## EXAMINATION of the SEDGEFIELD PLAN

### Questions

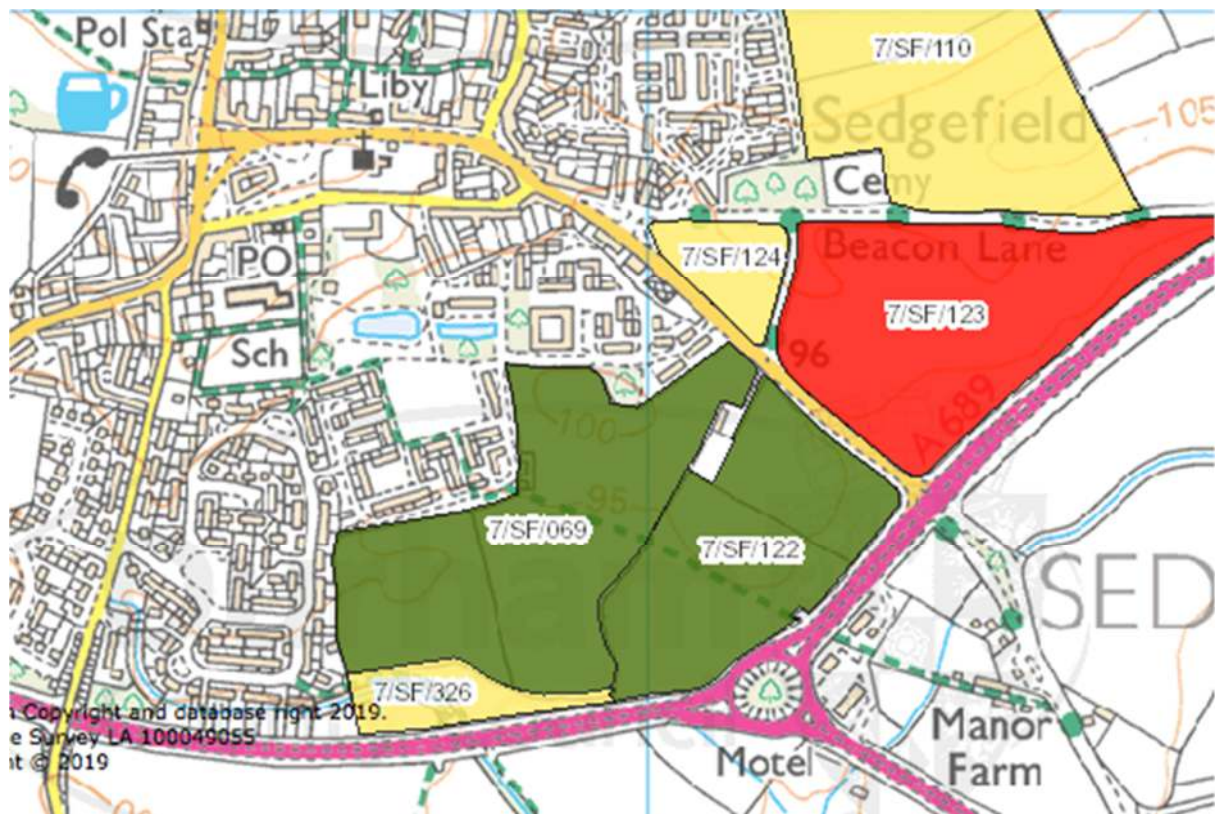
Q2. I note the built-up area boundary is based on planning permission commitments. However the SHLAA 2019 and its associated maps show site 7/SF/122, land at Stockton Road, granted planning permission on appeal, as extending further than that indicated by the proposed built-up area boundary. The Plan built-up area boundary does not extend as far east as that shown on the SHLAA maps. Furthermore, I cannot trace an allowed appeal relating to Stockton Road on the Council's web site search. I can only discover an appeal, which was withdrawn. Please can either the Town Council or the Council clarify the reason there is a difference in these boundaries and that permission has been granted on the land at Stockton Road and if so the extent of the boundary?

I attach screen shots of the relevant map and built-up area boundary shown in the Plan.

- *The proposed built-up area boundary is reflective of existing permissions.*
- *Permission was refused for a hybrid proposal (ref: DM/15/03808/OUT) on the South of Eden Drive site for a total of 300 units (220 in outline and full permission for 80).*

- *This was subsequently allowed at appeal - reference: APP/X1355/W/16/3150609*
- *Reserved matters (ref: DM/17/01322/RM) was approved for 197 on the larger portion of the site (SHLAA ref 7/SF/ 069).*

- *Both schemes have started on site.*
- *SHLAA site 7/SF/122 has not been split up to reflect the permission on part of that site, and therefore covers the paddock to the east which is currently the subject of a separate planning application (pending consideration for 60 units – ref: DM/18/00536/FPA).*

- *The Town Council propose a built-up area boundary which effectively excludes the eastern portion of site 7/SF/122 which is currently under consideration, as the Town Council consider that sufficient new housing is already in place.*

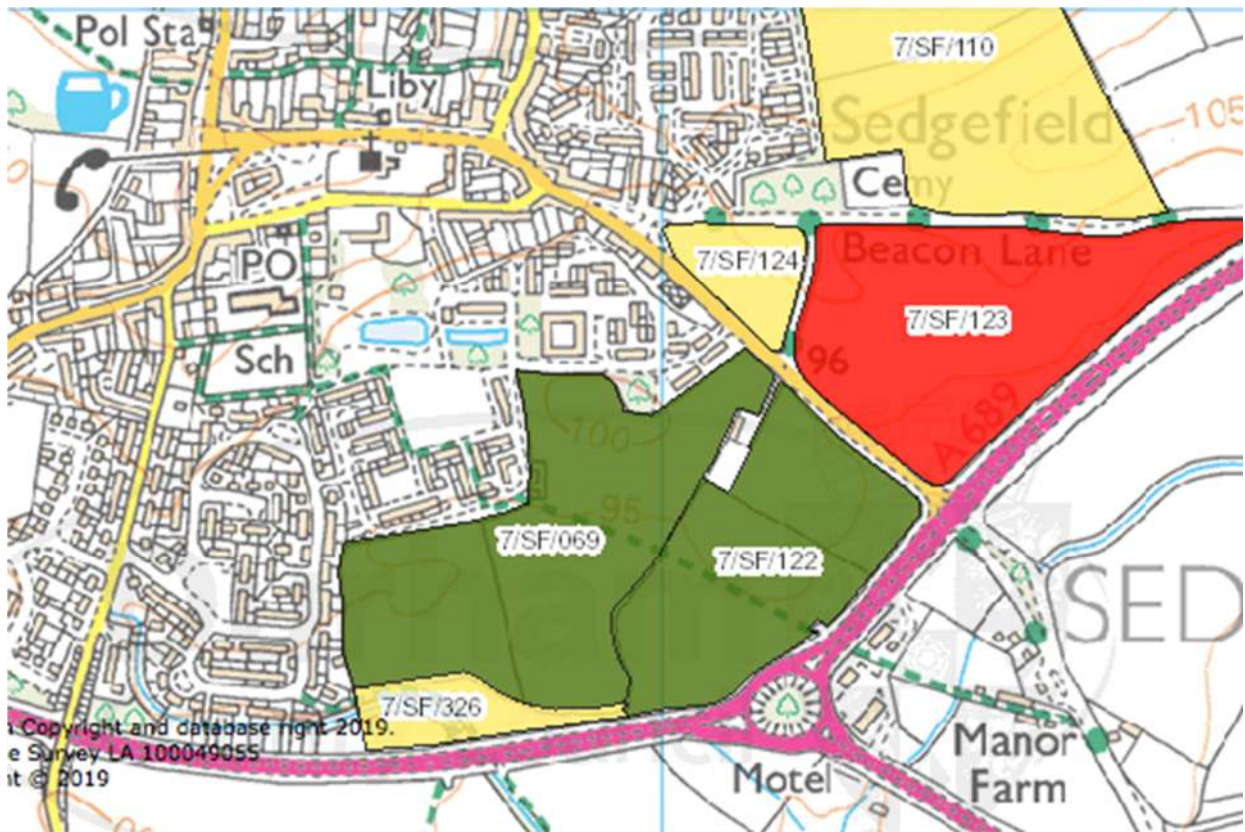
Q3. The Policy justification on page 23 refers to a field “at the entrance to the community” where there is a need to protect the ridge and furrow archaeology and views of the church. Where is this land? If so, is it the land that I refer to above that has been excluded from the built-up area boundary?

*The field in question is referred to localised as the ‘three-cornered field’ and is identified as the yellow triangle labelled 7/SF/124 below, just outside the built-up area boundary (see map below).*
